CITY OF West Linn

STAFF REPORT FOR THE PLANNING COMMISSION

FILE NUMBER: SUB-13-05

REQUEST: 4-lot subdivision at 4997 Summit St.

SHEET NUMBER: **C2.1**

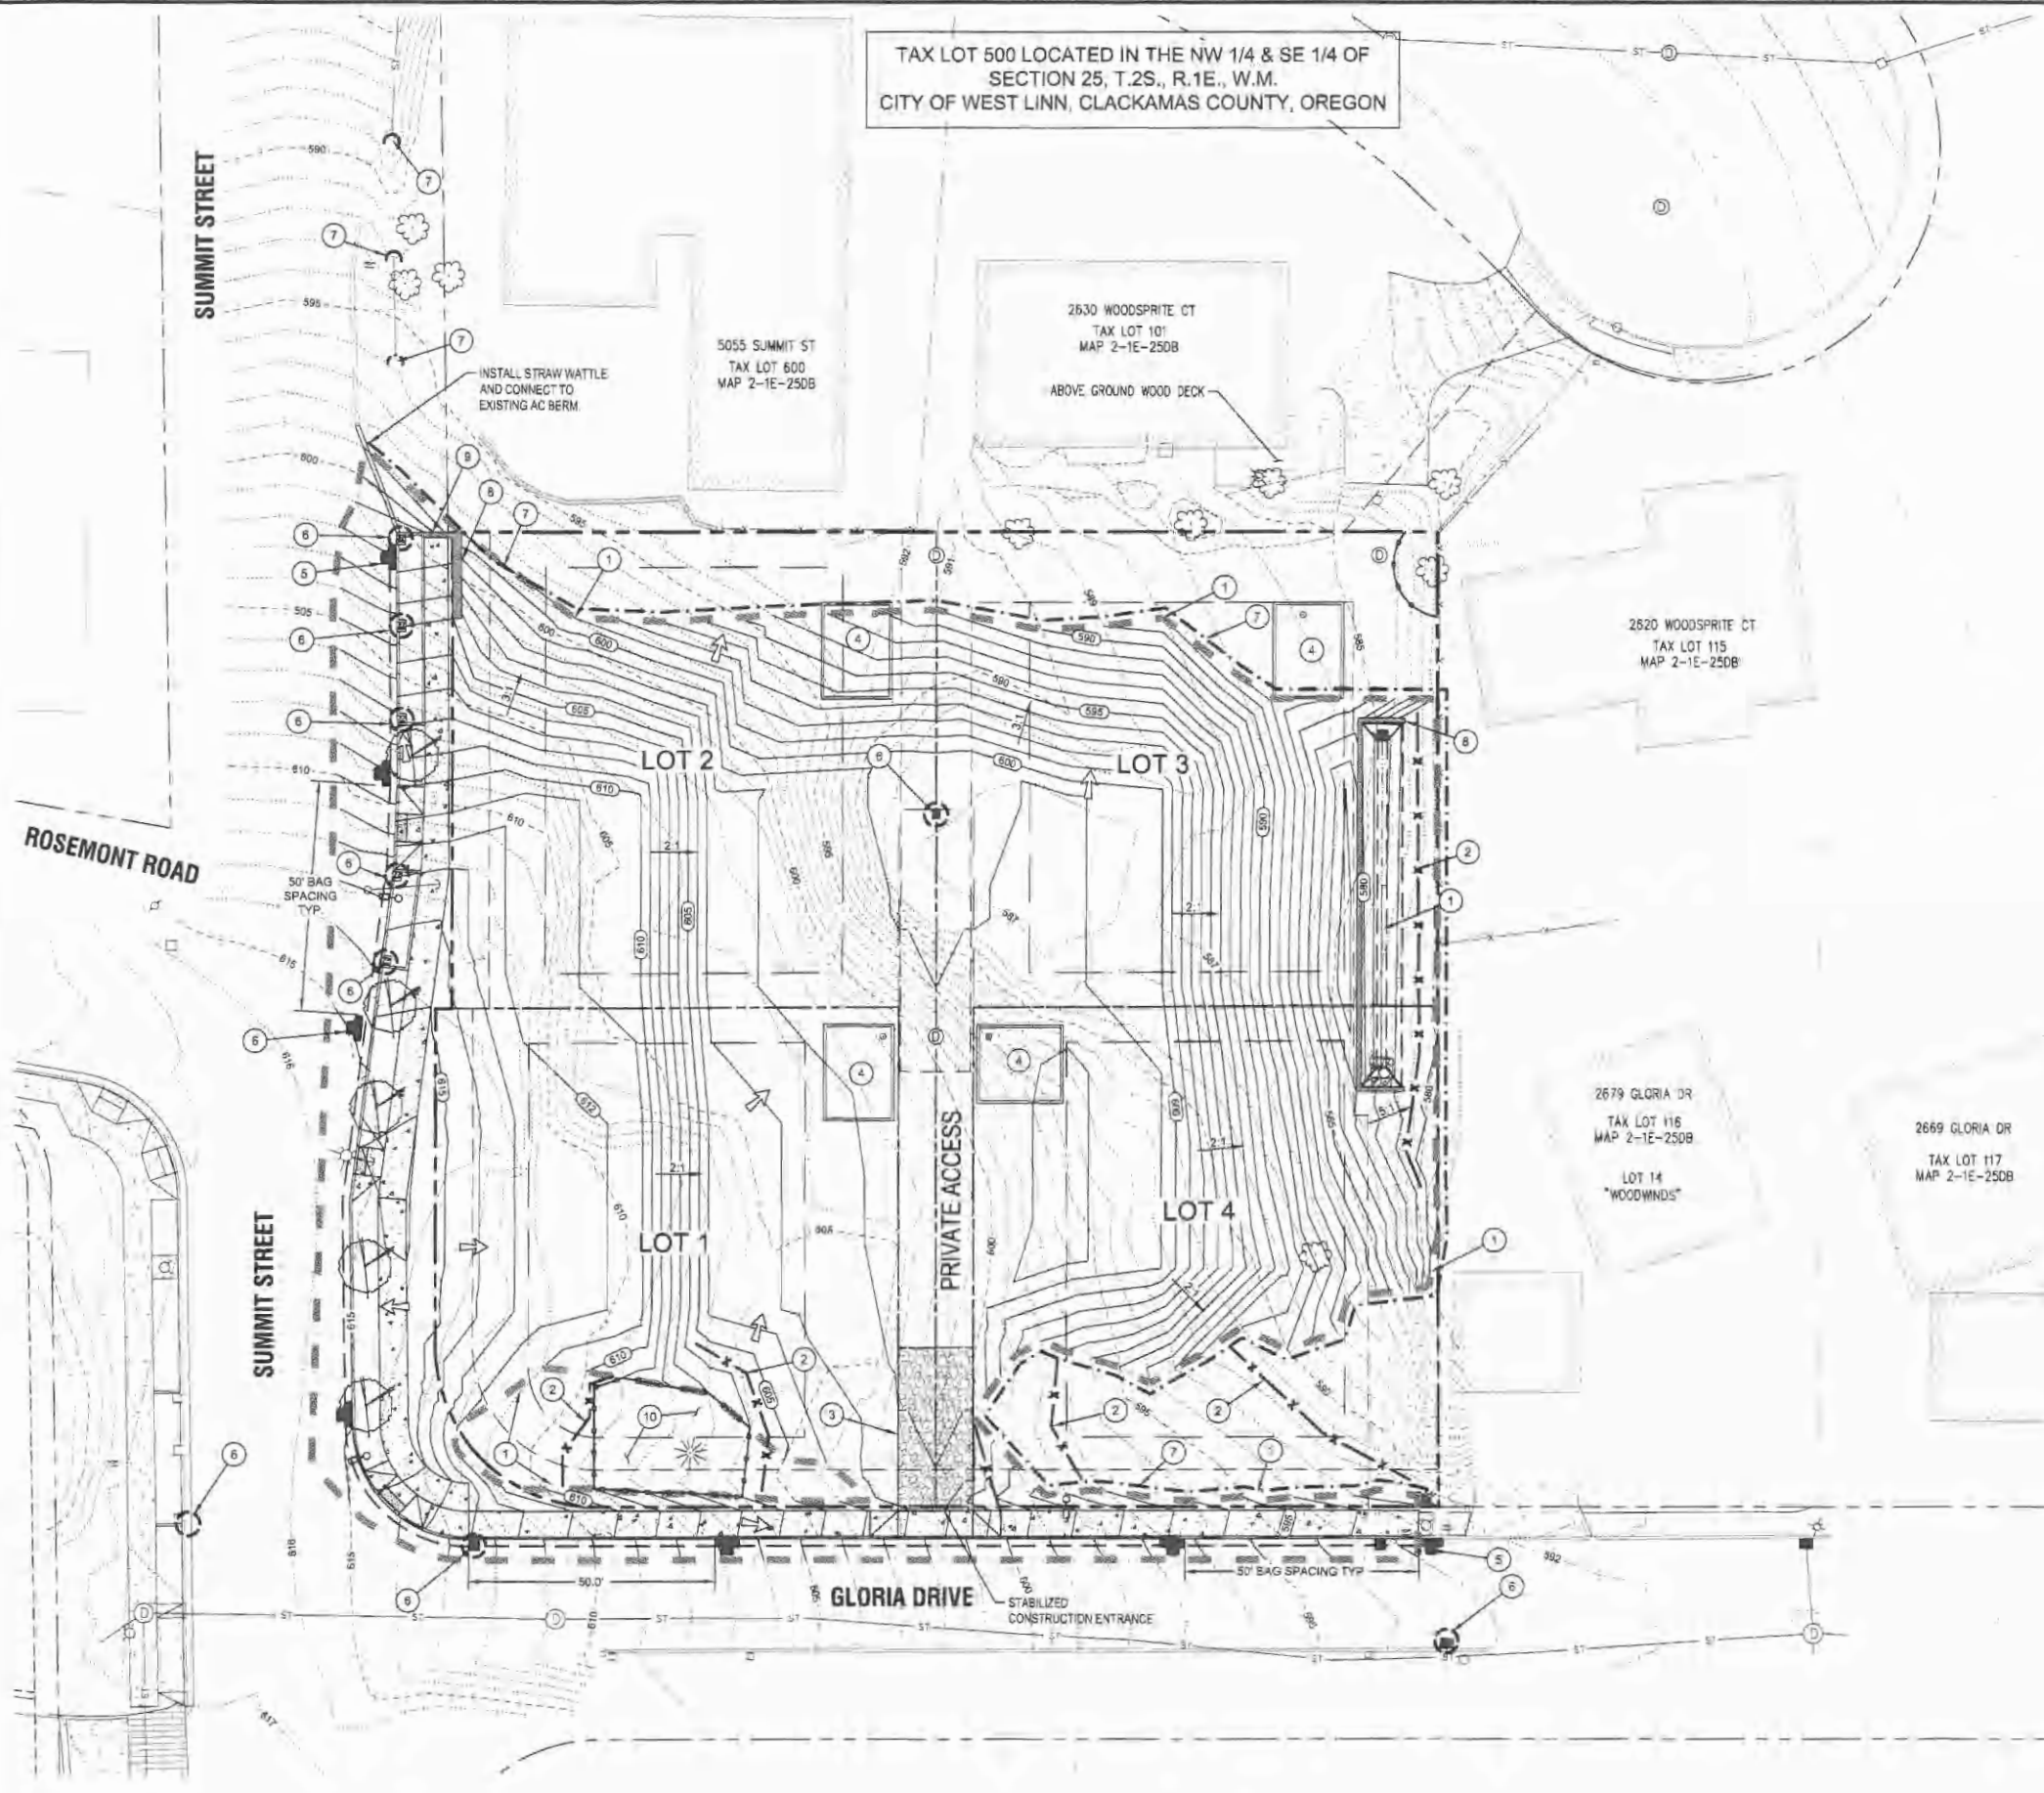
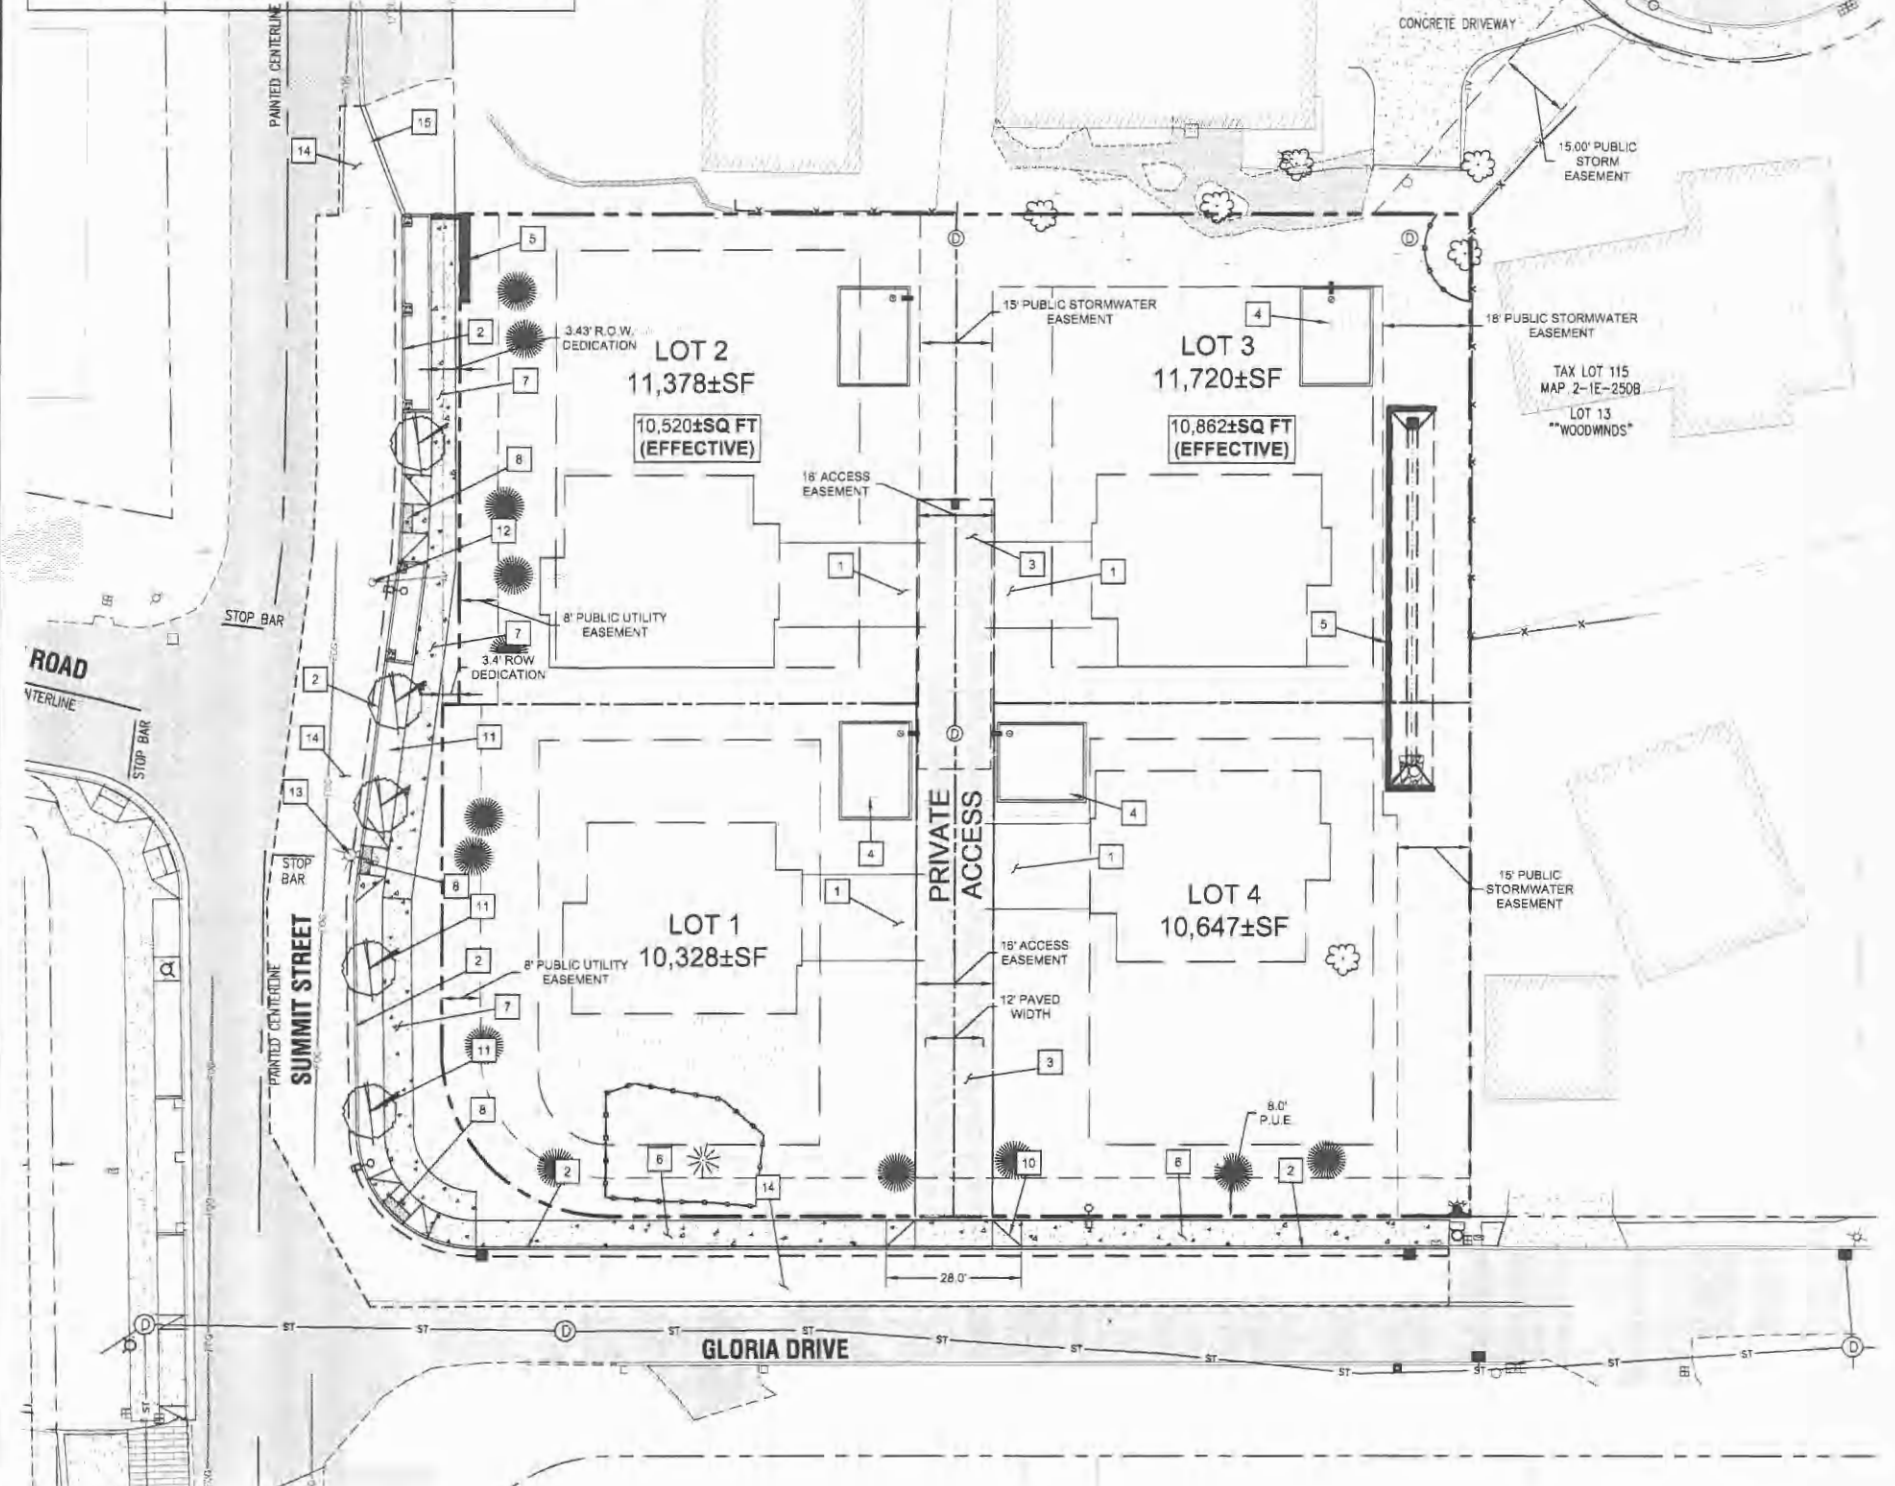
Staff Response 6: Along Gloria Drive on the map portion of Sheet C2.1 Site Plan the applicant proposes a curbtight sidewalk with no planter strip to match existing conditions to the east. The sidewalk along Gloria will be six feet wide. There are not adjacent sidewalks on either direction on Summit. The applicant proposes a six-foot-wide sidewalk and six-foot wide planter along Summit, with street trees. Along Gloria the applicant did not propose street trees due to the lack of a planter strip but street trees are still required, even if they are across the sidewalk from the street. Condition of Approval 4 is recommended to ensure there are street trees on Gloria as well (see Staff Response 32 below). Staff determines the criteria are met upon the inclusion of Condition of Approval 4.
